**Engineering Service Bulletin**

Tiled Slide Cover Bolts		
		Number: FT-ESB-0012-REL
Issued by: <u>Ed Brunson</u>	Approved by:	Issued Date: 01-MAY-2018
Priority: Urgent	High <u>X</u> L	_OW
<b>1.0 Description of Affected Products:</b> Units with curved entry steps.		
<b>2.0 Affected Units:</b> Realm: 9048-9049, 9051, 905 IH: 6631-6641, 6643-6644	53-9057	· · ·

3.0 Issue: There is a possibility of missing, or not enough bolts installed on the tiled cover above the sliding step well cover.		
<b>4.0 Solution:</b> Install missing screws.

Figure: 2 (Chair Removal)

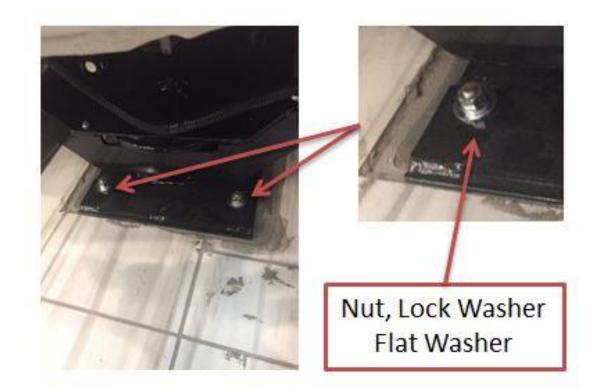
- **7.2.4** Ensure the Passenger Co-Pilot Chair is centered within its travel range front to back.
- **7.2.5** Raise the back skirt of the chair and locate the two (2) nuts, lock washers, and flat washers that hold down the rear of the base. Remove and save for later. *See Figure: 2*

- **7.2.6** Raise footrest and locate the two (2) nuts, lock washers, and flat washers that hold down the front of the base. Remove and save for later. *See Figure:* 2

- **7.2.17** Replace the two (2) nuts, lock washers, and flat washers that hold down the front of the base and torque to 30 ft-lbs. *See Figure:* 2.
- **7.2.18** Replace the two (2) nuts, lock washers, and flat washers that hold down the back of the base and torque to 30 ft-lbs. *See Figure:* 2.
